**COUNTY OF SAN MATEO
PLANNING AND BUILDING DEPARTMENT**

SUBJECT: EXECUTIVE SUMMARY: Consideration of a Minor Subdivision, pursuant to Section 7010 of the San Mateo County Subdivision Regulations, to subdivide a 23,641 sq. ft. parcel into three (3) parcel lots and assign the name "Cardinal Court" to the new private street, located at 2050 Santa Cruz Avenue, in the unincorporated West Menlo Park area of San Mateo County.

County File Number: PLN 2016-00226 (Silicon Valley Real Ventures LLC)

SUBJECT: Consideration of a Minor Subdivision, pursuant to Section 7010 of the San Mateo County Subdivision Regulations, to subdivide a 23,641 sq. ft. parcel into three (3) lots and assign the name “Cardinal Court” to the new private street, located at 2050 Santa Cruz Avenue, in the unincorporated West Menlo Park area of San Mateo County.

A PROPOSED ROADWAY SECTION AT TREE #1
 SCALE: HORZ: 1" = 4' VERTICAL: 1" = 2'
 NOTE: EXISTING ELEVATIONS SHOWN IN PARENTHESIS

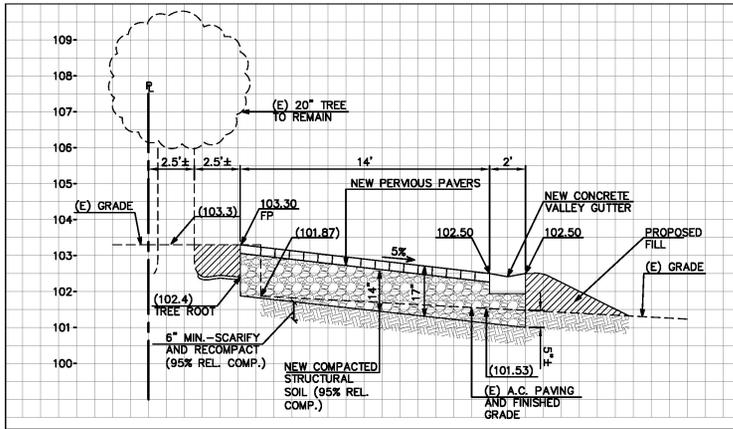
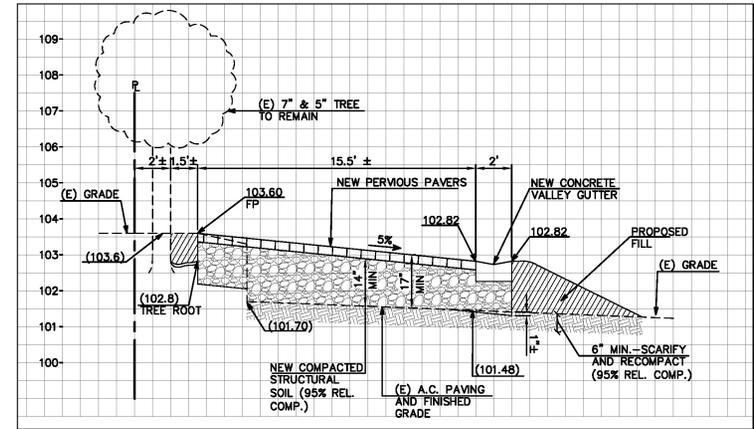
- The applicant's civil engineer shall submit a cross-section to show how the raised roadway will: (1) minimize impact to the oak trees slated for preservation (#s 1, 2, 26 and 27); Tree Protection Plan, Attachment I); and (2) reconcile with the parcel's topography and future driveways serving Lots 2 and 3.

- e. Perform the same type of tree root exploration – with a section diagram provided by the applicant's arborist/engineer - around tree Nos. 2 and 26 as was performed around tree No. 1 and provide recommendations about the appropriate tree protection measures for those trees;

- i. Evaluate the document entitled "Proposed Roadway Section at Tree #1" – as well as similar cross sections to be provided by the applicant on the other two oak trees to be preserved along that left side of the proposed roadway -and provide recommendations regarding the preservation of trees along proposed Cardinal Court during and after construction. Review all cross sections given a reduced roadway width should that reduced width be allowed by Menlo Park Fire Protection District. In the event

Response: Those sections have been submitted, as shown in Attachment E. The rationale that the raised roadway will be adequate to preserve the subject trees is discussed in Section A.3. of this report. With regard to the slope of the driveways leading from the elevated roadway to access Lots 2 and 3, the applicant's civil engineer has assured that their average incline would range from 4% to 8%, well below the maximum allowed incline of 20% as mandated by the Department of Public Works (DPW). Recommended conditions of approval require the recommended roadway revisions, together with all associated preservation measures, to be addressed prior to the Final Map's recordation.

BERM DETAIL

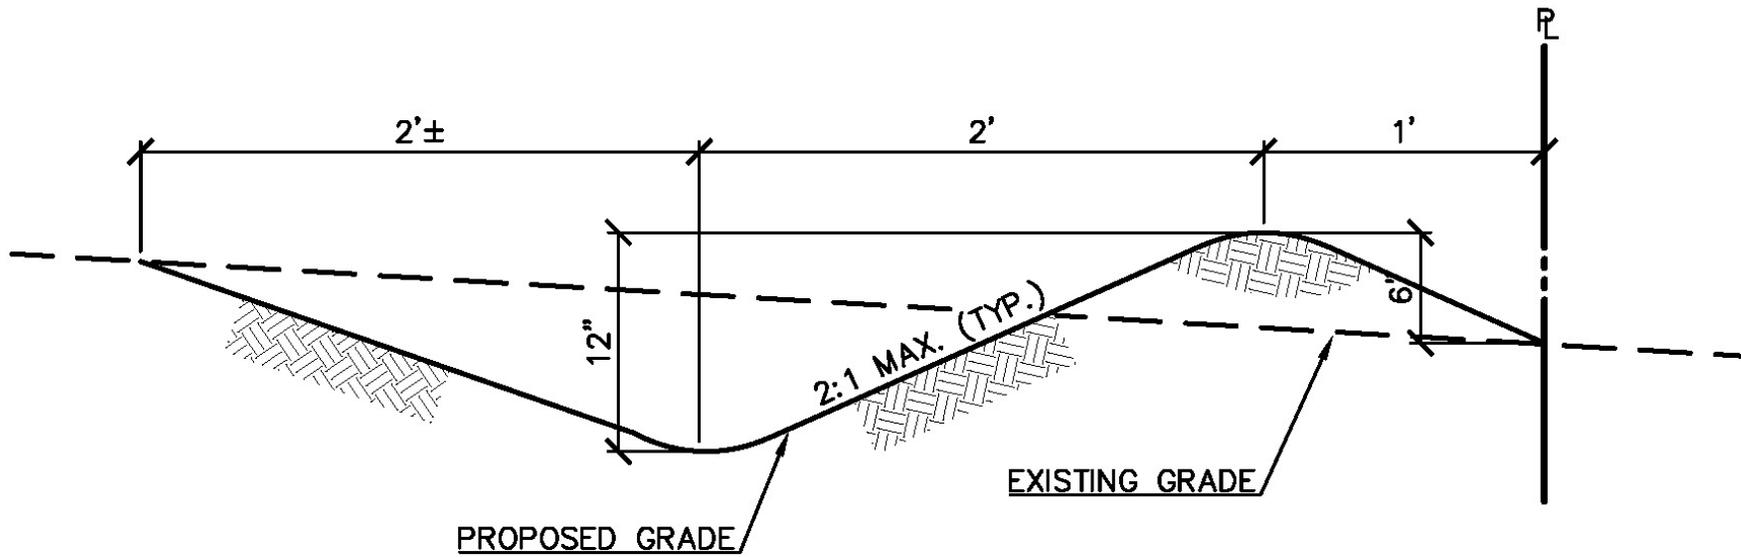
- The applicant shall revise the project drainage plan to include a 1-foot higher berm along the entire length of the drainage swale along the northern border of the site (directly adjacent to 2042 Santa Cruz Avenue).

- 3) The applicant shall be required to revise the project drainage plan to include a one-foot higher berm along the entire length of the drainage swale located along the northern border of the site (opposite Crocus Court and directly adjacent to neighbors living at 2042 Santa Cruz Avenue). This revision shall include a simple cross-section of the drainage swale in proximity to the boundary of 2042 Santa Cruz Avenue. Require the applicant to submit revised grading and drainage plans as needed for review by the Planning Commission.

Response: That revision has been made and is shown in Attachment G. As part of the revised Tentative Map details, a condition of the Final Map's recordation will be that the drainage feature be constructed, inspected and approved as shown.

Image 1:
Cardinal Pass
Road Section
for Tree #1

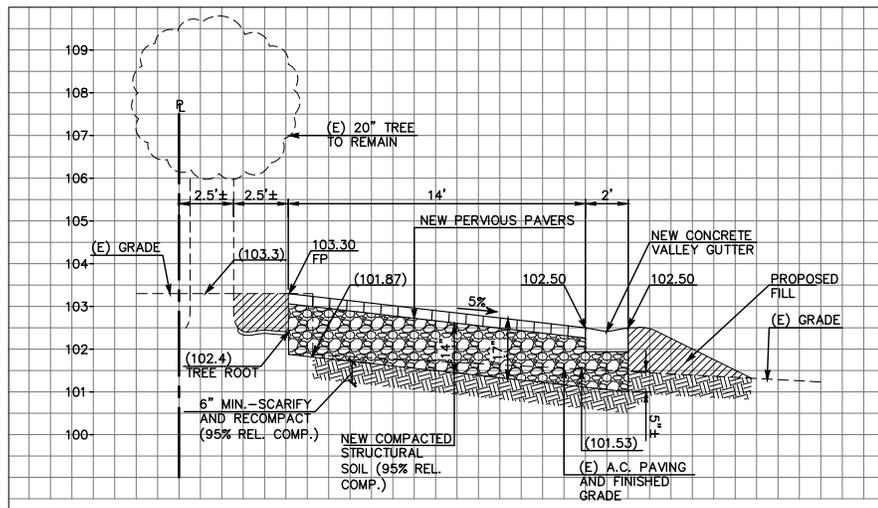
The plans indicate the proposed Cardinal Pass Road will be constructed within one foot of trees #1, #2, and #26. It was determined during the site visit on February 2, 2017 that tree #3 was not suitable for transplanting and #4 was already designated for removal. The “Proposed Road Way Sections” indicate the grade raised and sloping upward to meet the existing grade of the trees (Image 1). This section shows the existing fill within one foot of the trees to be removed and the entire roadway designed with Structural Soil® and pervious pavers. The existing conditions include an asphalt driveway about 5 to 6 feet from the trunks. There is a small rock wall about 12 inches high running parallel to the driveway about 5 feet from the trees. The soil slopes upward to the trunks at least two feet above from the existing driveway.

Image 11: Roadway Section with existing root location and ultimate height/depth of Cardinal Pass Way.

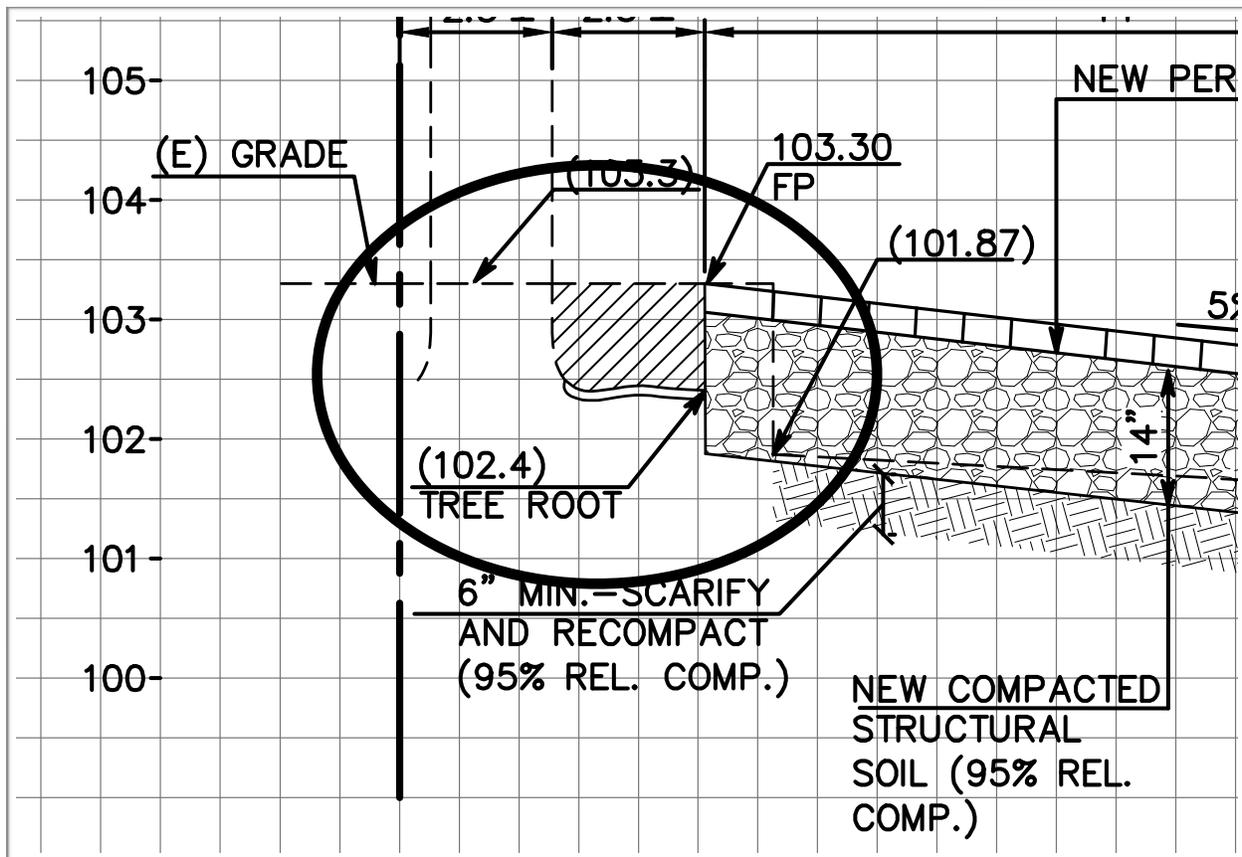
Root removal or cutting will significantly compromise the trees #1, #2, #26, and #27 and a soil replacement regime could allow for tree preservation and the construction of the roadway with varying results. The trees could survive this process or they could perish within a few years. Nevertheless there would be infrastructure in place to plant new trees with success in the event the trees decline or die.

There is another concern with the roadway section of the plan that could be a result of poor guidance and no fault to the engineer. The sections for each tree indicate the new grade of Cardinal Pass Way with all the Structural Soil® and pavers will match the existing grade. However, this may not be necessary because the trees were somewhat buried in fill with roots about one foot below grade to start with. For example the new finished grade is approximately one foot higher than the depth of the significant roots identified in most instances. There may not be a need to raise the roadway surface this high over the existing roots unless it is for structural or road stability purposes (Image 11). Another alternative is to just use pavers and Structural Soil® under the trees, or within a designated area, and construct the remaining portion of the roadway with other materials. This would allow for a “Tree Well” under the trees that could support both existing or new plantings if required.
